**The City of New York**  
**Manhattan Community Board 8**

**Parks Committee Meeting**

Thursday, April 4, 2013, 6:30 PM  
Lenox Hill Hospital  
Robert Carmel Conference Room  
130 E. 77<sup>th</sup> Street

Hosea  
Welded Steel  
2005

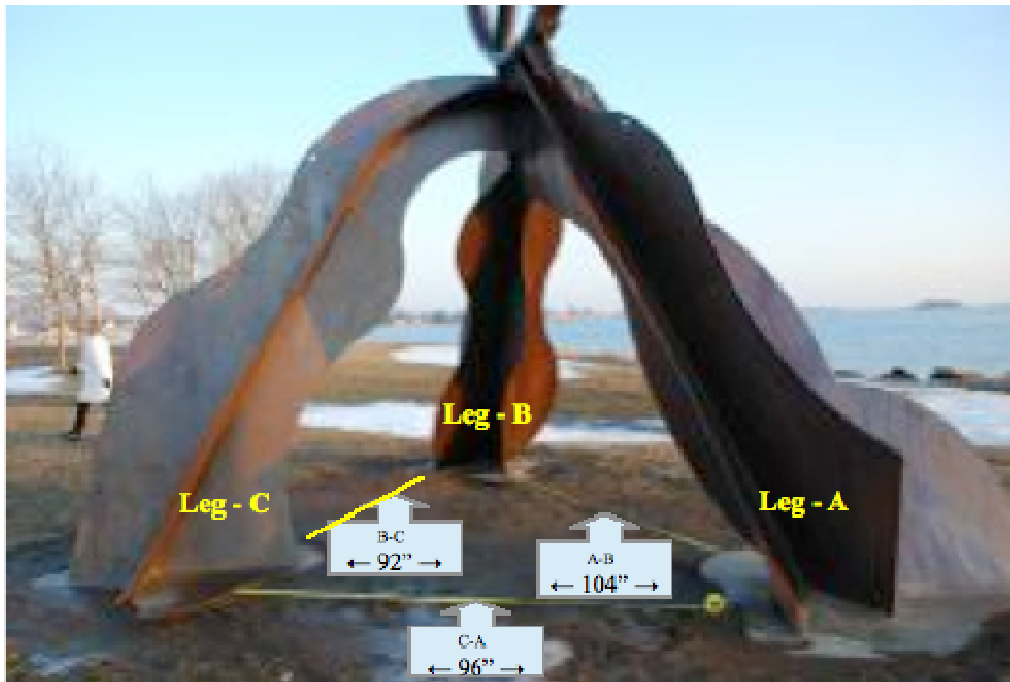
The committee had two concerns about the project: adequate lightening and the possible effect of placing the large sculpture over a non-activated water-feature area of the park.

On the lighting issue, CB8M members noted that the proposal does not include additional lighting around the sculpture. Members wondered if this large sculpture would cause a safety hazard or encourage graffiti if additional lighting were not included as part of its installation.

In addition, the proposal calls for sitting the sculpture above an area intended to be a fountain. Although this fountain has not yet been fully installed or activated, the area contains a below-ground vault that holds the pipes for this water feature. The committee asked for assurances from the City that the sculpture would not endanger the plumbing under the plaza. Ms. Eley promised to provide to responses to the Committee's concerns.

"We have reviewed the weights with Parks Engineers and they have confirmed that they don't have a concern with the weight load, as it is distributed over the three footings. It ensure that it is not any greater than a group of people congregating in the plaza.

Lighting is not required by Parks. It is the exhibitors aesthetic choice to add lighting. I have discussed this with the gallery and we will determine if there is additional lighting needed once the piece is in; however, we believe there will be sufficient park and ambient light to keep the piece visible to passersby. Should any problems arise though, we will look into adding additional lighting."
